# Access Compliance Report

## Public Rights-of-Way

### (Pedestrian Signals)

Intersection ID: N/A	Main Street:	Cross Street: N/A	Location: N/A
ADA ID: 43D50AE34AA9	Signal Type: One Push Button-Non APS	Overall Compliance: No	Severity Score: BTN 1: N/A BTN 2: N/A No BTN: N/A
Codes/Mitigation Info/Possible Solution		Field Measurements/Component Compliance

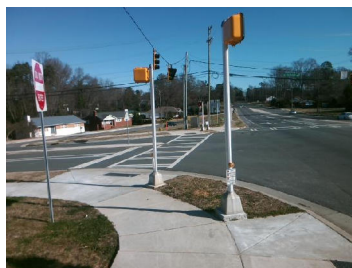
PROW/ADA: R404.2, R406.2

N/A	B 1 FWD Approach Width (in)	N/A	N/A	B 2 FWD Approach Width (in)	N/A
N/A	B 1 FWD Approach Obstruction?	Yes	N/A	B 2 FWD Approach Obstruction?	N/A
N/A	B 1 FWD Approach Obstruction Dist (in)	2.0	N/A	B 2 FWD Approach ObstructionDist (in)	N/A
N/A	B 1 PARA Approach?	Yes	N/A	B 2 PARA Approach?	N/A
N/A	B 1 PARA Approach Constrained?	No	N/A	B 2 PARA Approach Constrained?	N/A
Yes	B 1 PARA Approach Reach (in)	3.0	N/A	B 2 PARA Approach Reach (in)	N/A
N/A	B 1 PARA Approach Width (in)	N/A	N/A	B 2 PARA Approach Width (in)	N/A
N/A	B 1 PARA Approach Obstruction?	Yes	N/A	B 2 PARA Approach Obstruction?	N/A
N/A	B 1 PARA Approach Obstruction Dist (in)	2.0	N/A	B 2 PARA Approach ObstructionDist (in)	N/A
Yes	B 1 Clear Floor Space Slope (%)	0.3	N/A	B 2 Clear Floor Space Slope (%)	N/A
No	B 1 Clear Floor Space XSlope (%)	5.8	N/A	B 2 Clear Floor Space XSlope (%)	N/A
N/A	B 1 PAR Slope (%)	3.4	N/A	B 2 PAR Slope (%)	N/A
Yes	B 1 Height (in)	40.0	N/A	B 2 Height (in)	N/A

Possible Solutions: Provide Push Button Extension. Remove and Replace Clear Space.
